Service Update

18258 Wire Harness Potential Wear-Through

Reference Number: N182167990

Release Date: October 2018
Revision: 00

5141120

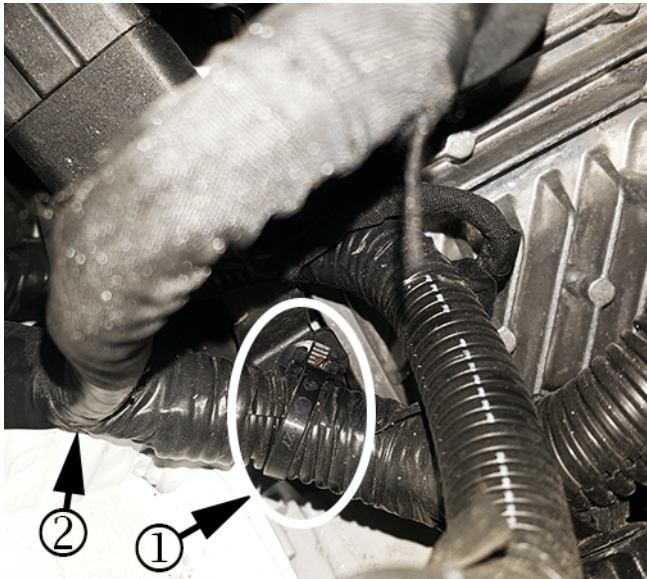
2. Remove the battery negative stud (1) to gain access to the harness junction (2).
